March 6th, 2023,
Project: Knife Kitchen And Cocktails

Thank you for taking the time to review drawings for **Knife Kitchen And Cocktails**, located at **3162 Piedmont Rd NE, Atlanta, GA 30305**

This is a response letter addressing your architectural plan review comments.

LIGHT COMMERCIAL PLAN REVIEW COMMENTS

LS-100
 Scale 3/16" = 1'-0"

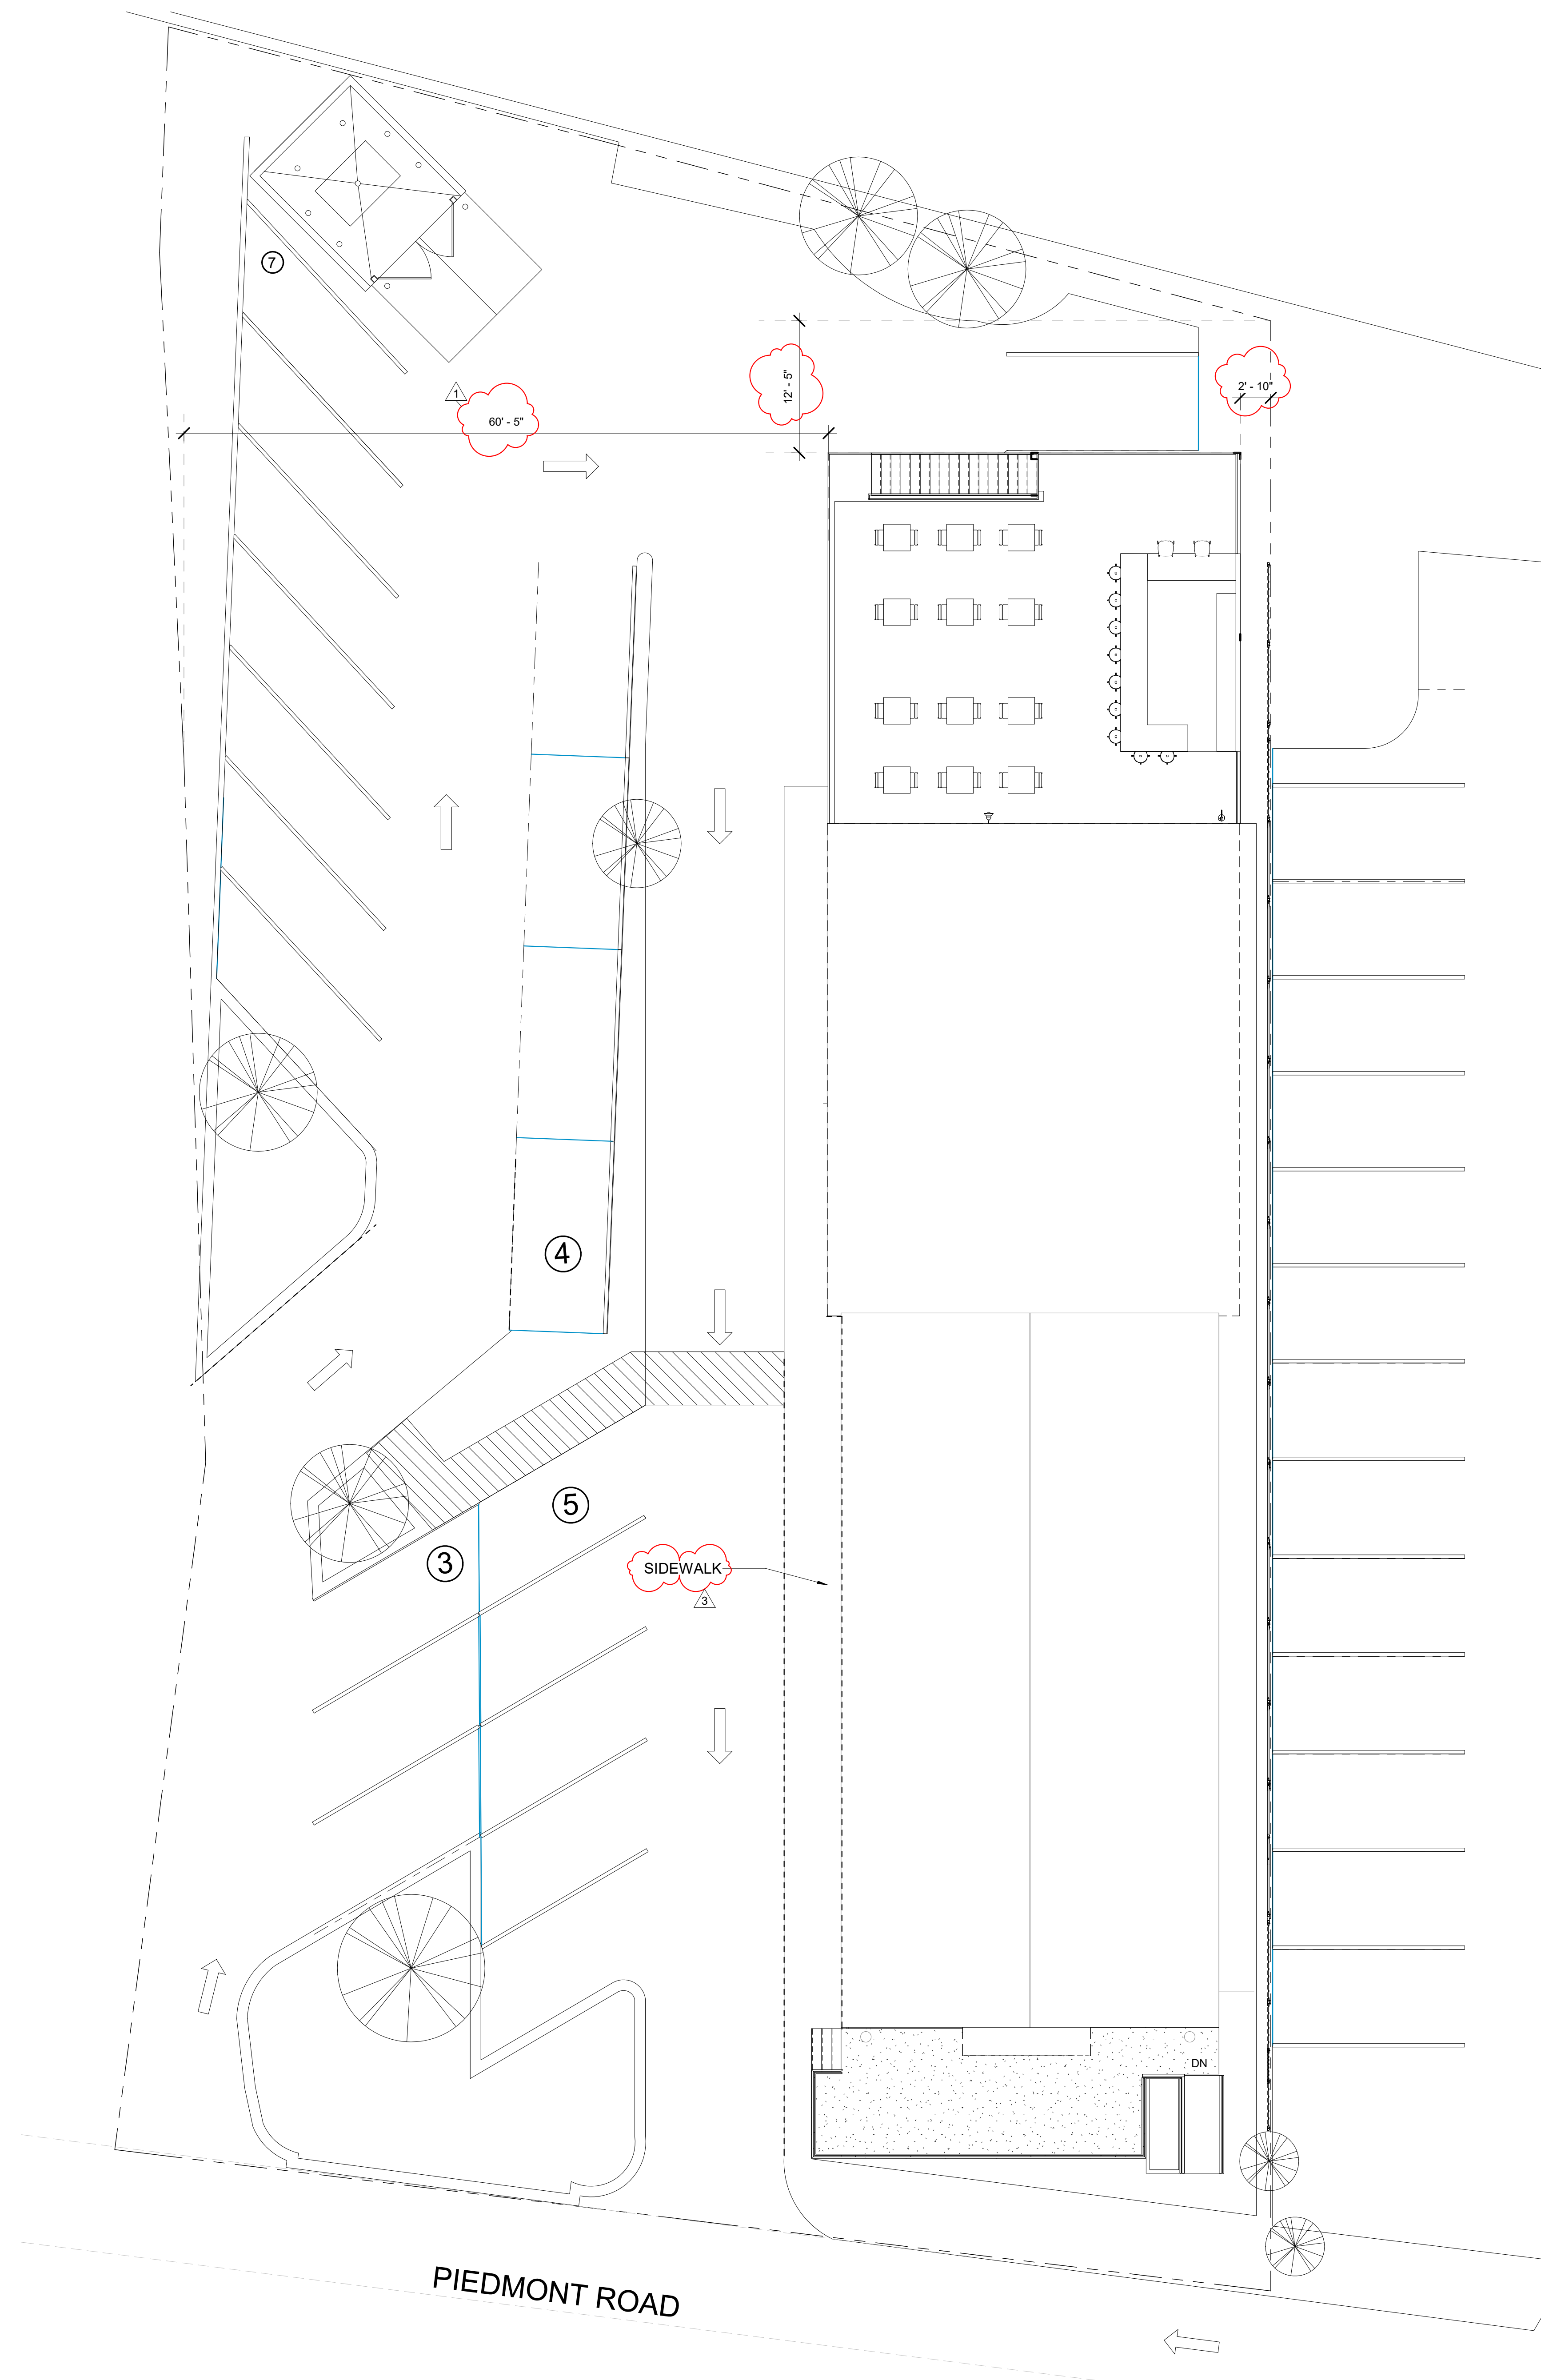
NO	SHEET	COMMENT	RESPONSE
1	LS-100	1. Back door cannot be existing	1. Sidewalk -serving the backdoor and the staircase- is highlighted per sheet SP-101, LS-100, A-101

PROPOSED BASEMENT FLOOR PLAN 3/16"= 1'-0" SCALE **02**

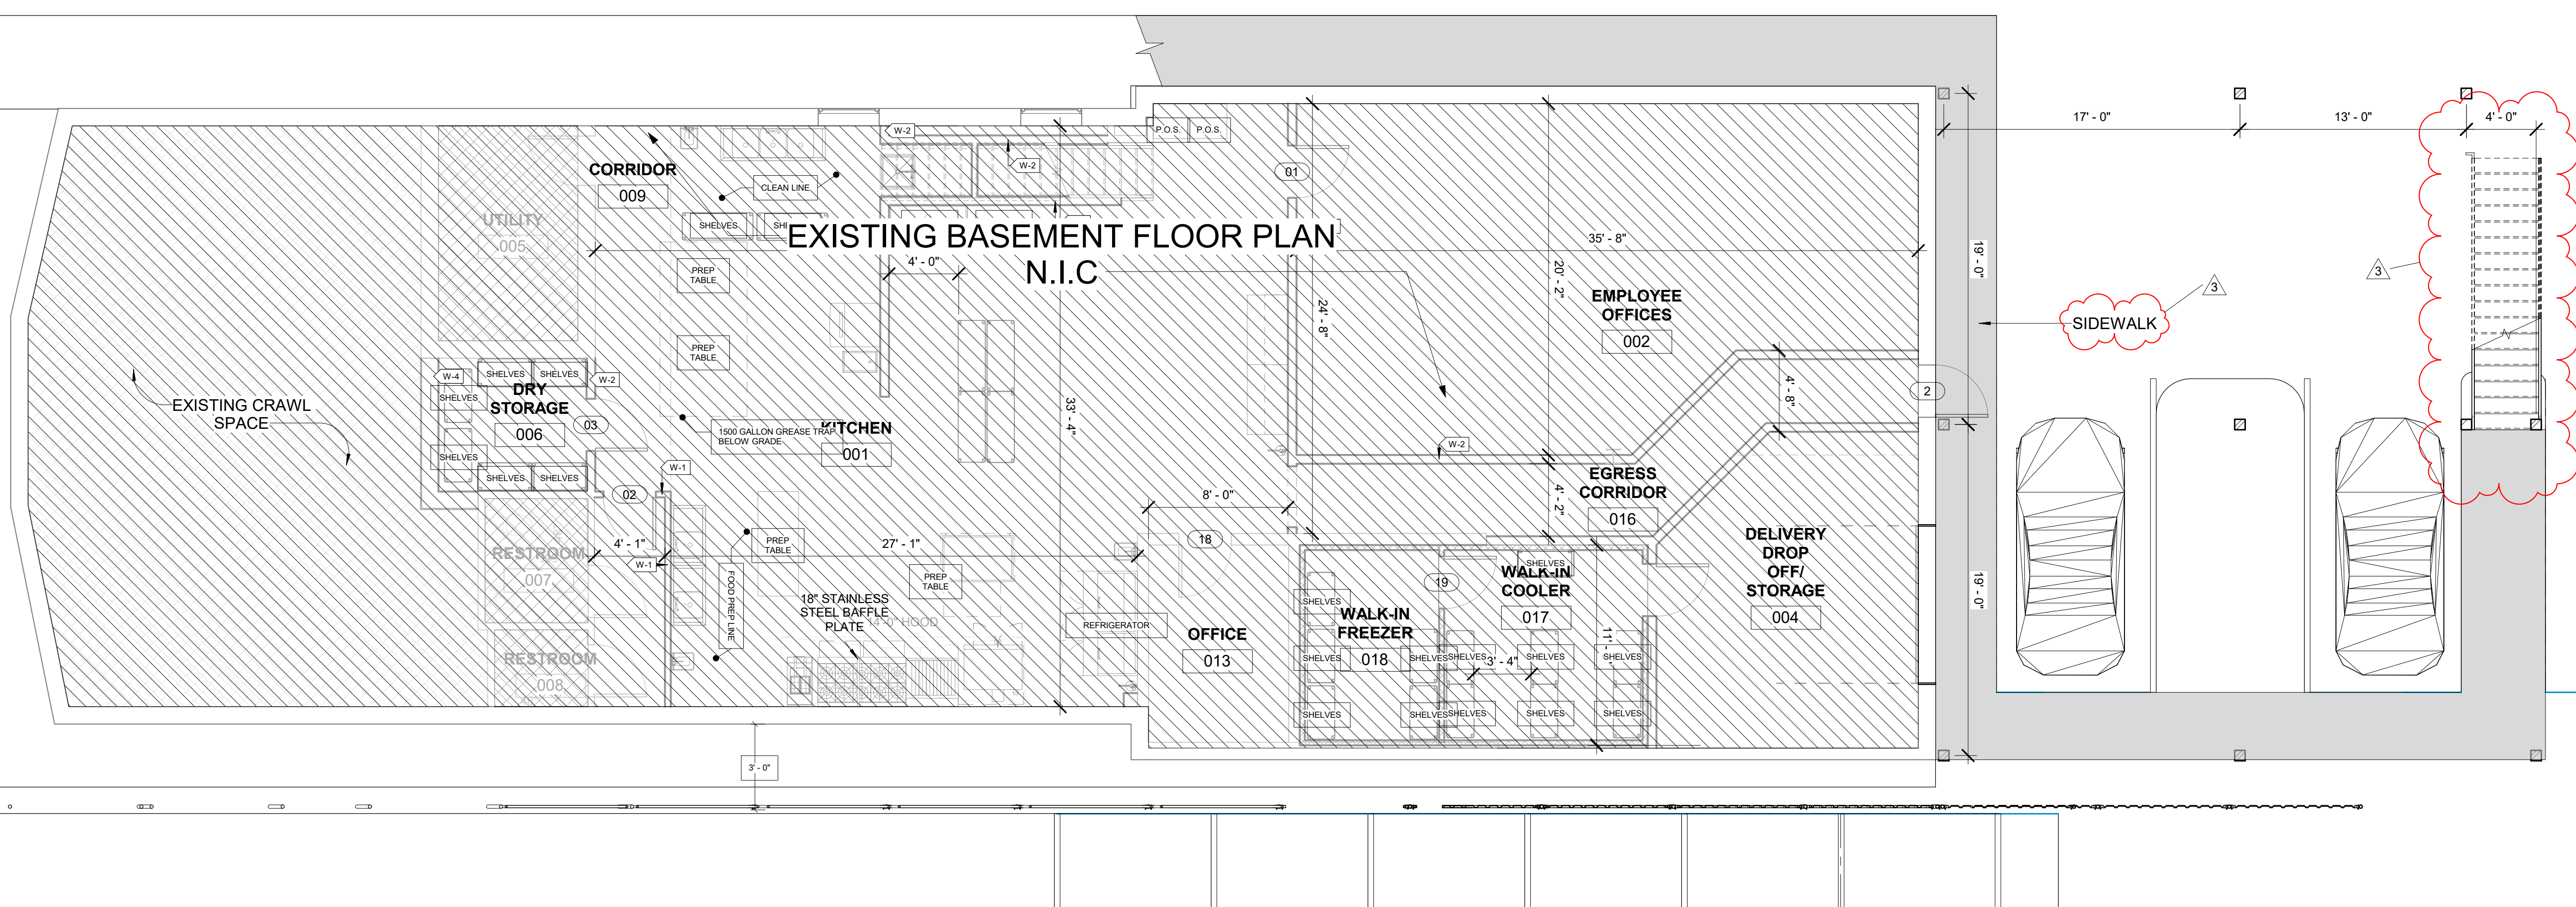
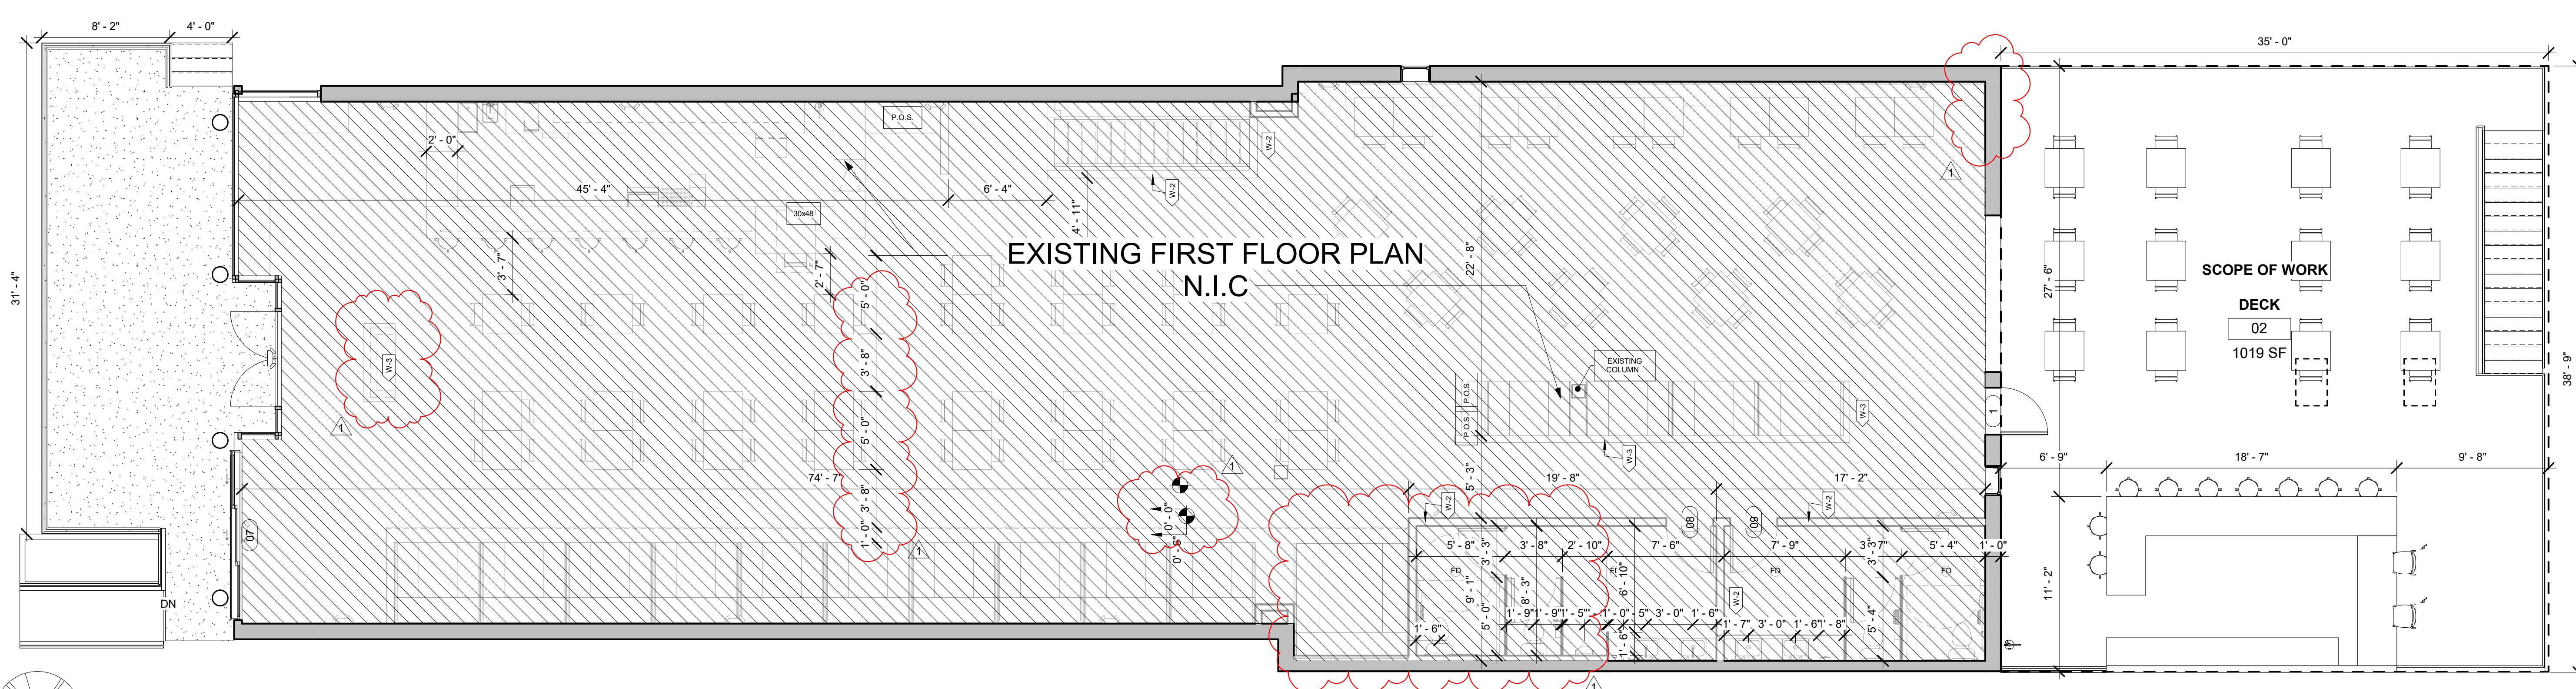
What is the new added area?
